**PROJECT:** Hacienda Higgins-Marquez  
Project Development Plan/Final Plan FDP#120022

**CITY OF FORT COLLINS  
ADMINISTRATIVE HEARING OFFICER  
TYPE 1 ADMINISTRATIVE HEARING  
FINDINGS, CONCLUSIONS AND DECISION**

CASE NUMBER: Project Development Plan/Final Plan #120022

# SITE PLAN FOR THE PROPOSED HACIENDA HIGGINS - MARQUEZ SUBDIVISION

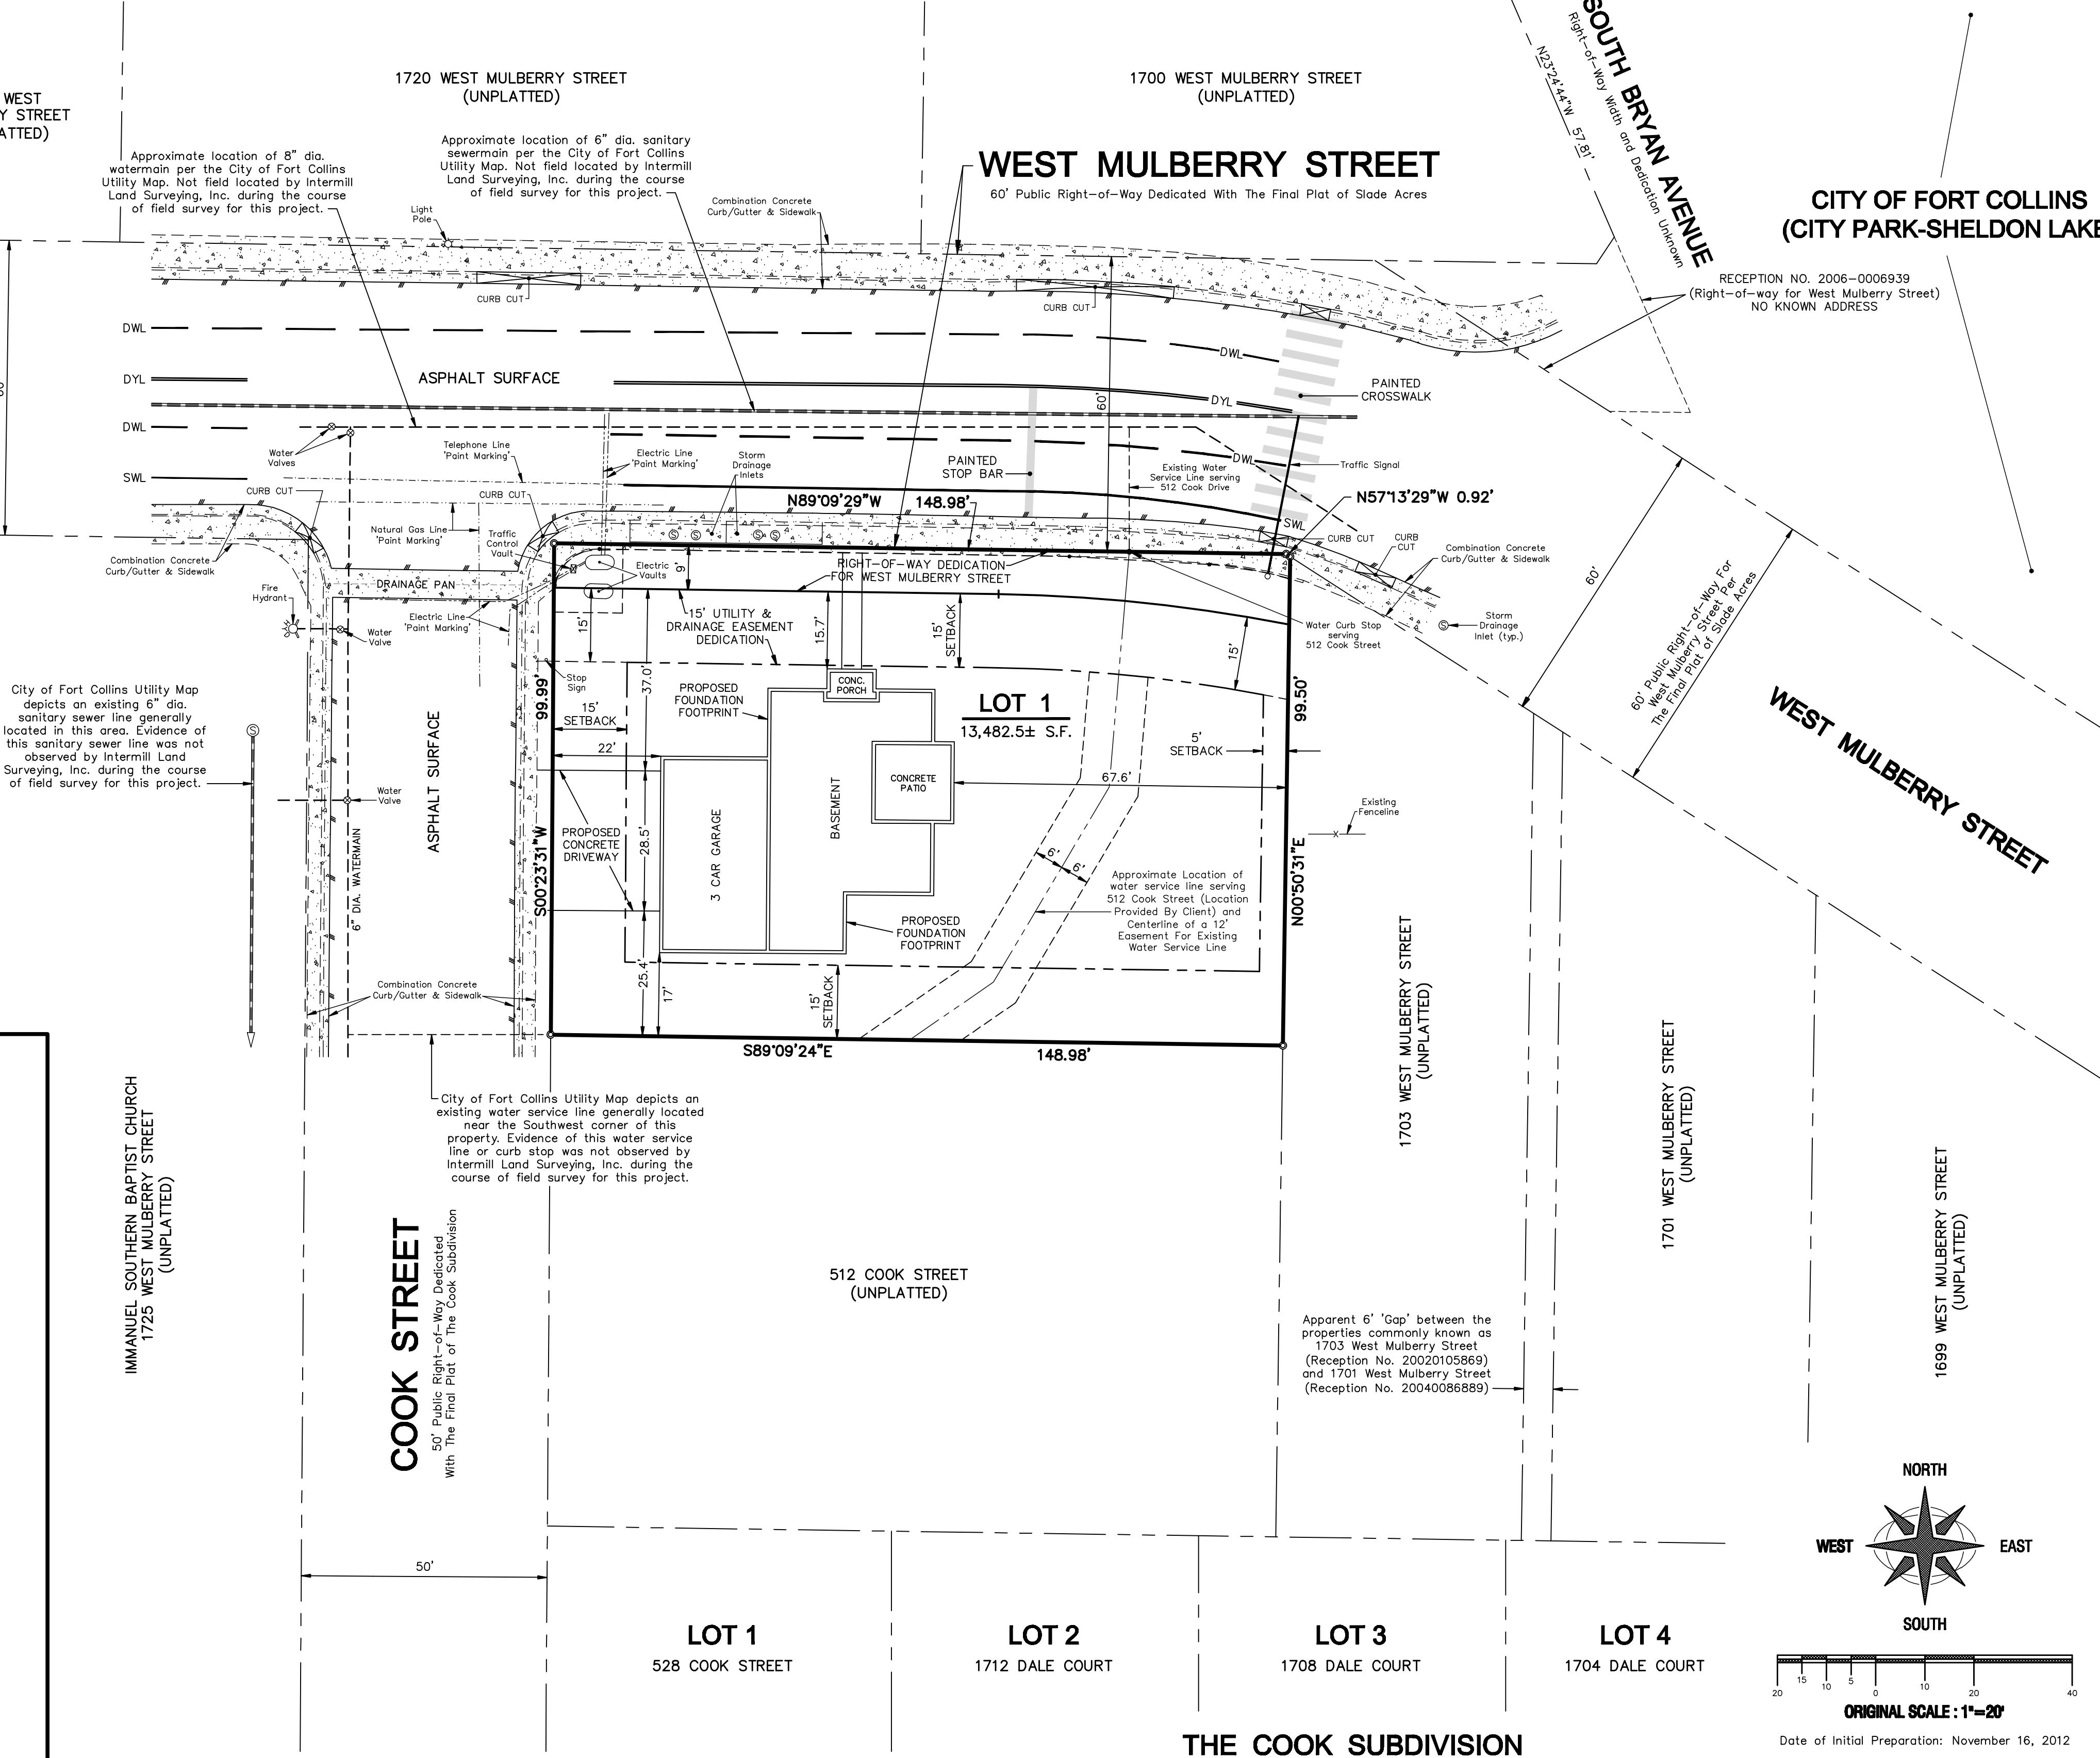
The single-family detached dwelling's living area is setback the required 20 feet; however, portions of the dwelling's front porch lay within the minimum setback area. Approximately 4.3 feet of the porch is within the minimum setback area, meaning the front yard setback as measured to the front of the porch is 15.7 feet.

The lot was required to dedicate additional right-of-way for Mulberry Street. At its narrowest point, 9 feet at the front of the lot along Mulberry Street will be dedicated as additional right-of-way. This dedication has reduced the building envelope in which to construct a dwelling and had no dedication taken place, the building would meet and exceed the minimum front yard setback.

Staff recommends approval of the modification. In evaluating the request, staff makes the following findings:

- (1) The granting of the modification would not be detrimental to the public good and;
- (2) The plan as submitted will not diverge from the standards of the Land Use Code except in a nominal, inconsequential way when considered from the perspective of the entire development plan.

FRONT  
& REAR  
ELEVATIONS

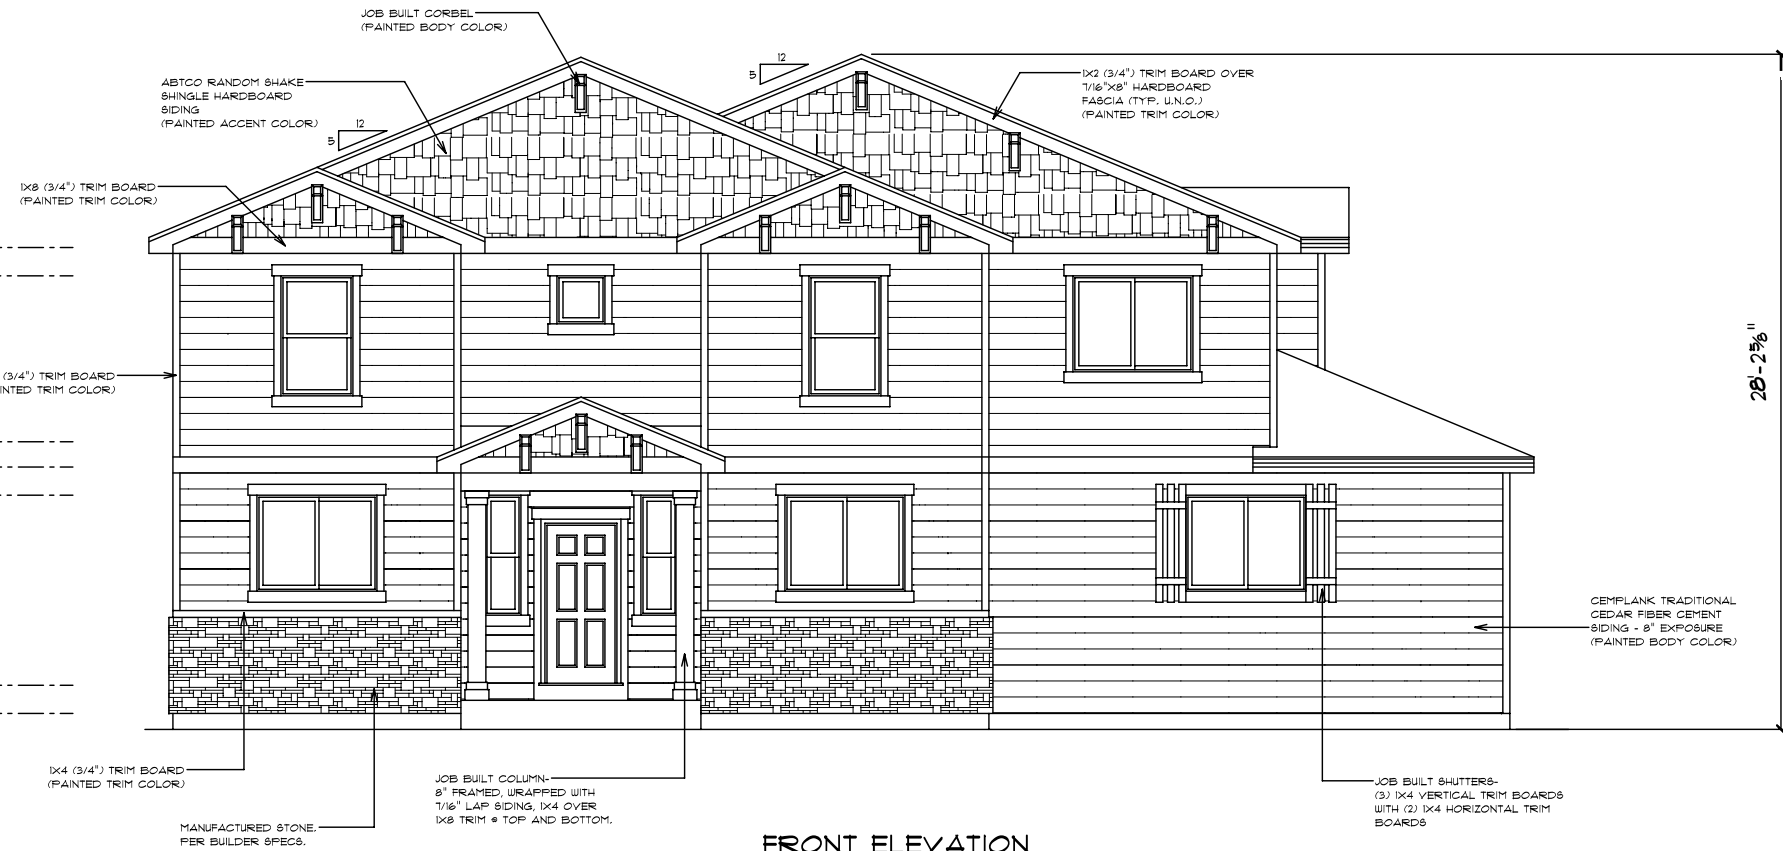
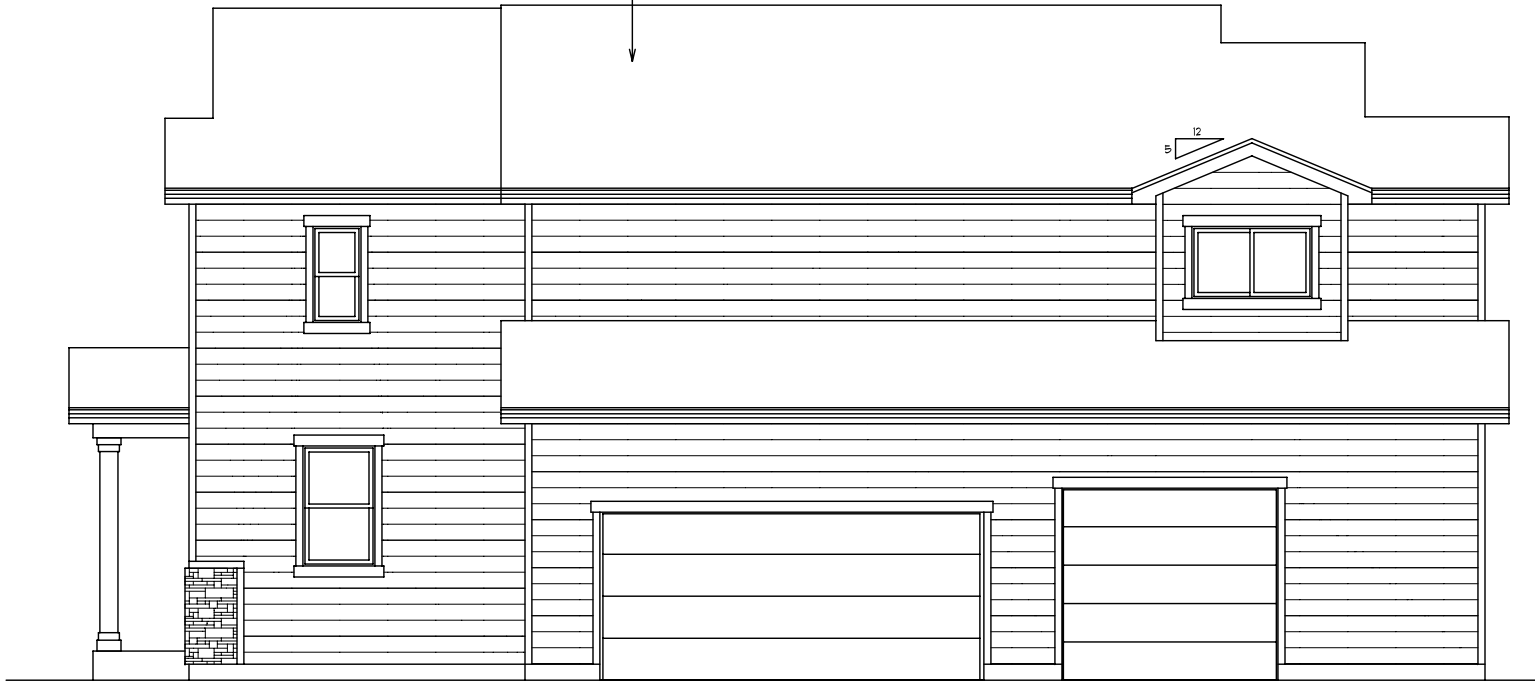
The single-family detached dwelling will exceed the current standard maximum of 28 feet by less than 3 inches. The building height for the structure will be 28.21 feet.

The additional few inches of height above the standard's maximum only occur near the pinnacle of two articulated roof lines; the vast majority of the roof and structure's height is below the 28 foot height maximum.

Staff recommends approval of the modification. In evaluating the request, staff makes the following findings:

- (1) The granting of the modification would not be detrimental to the public good and;
- (2) The plan as submitted will not diverge from the standards of the Land Use Code except in a nominal, inconsequential way when considered from the perspective of the entire development plan.
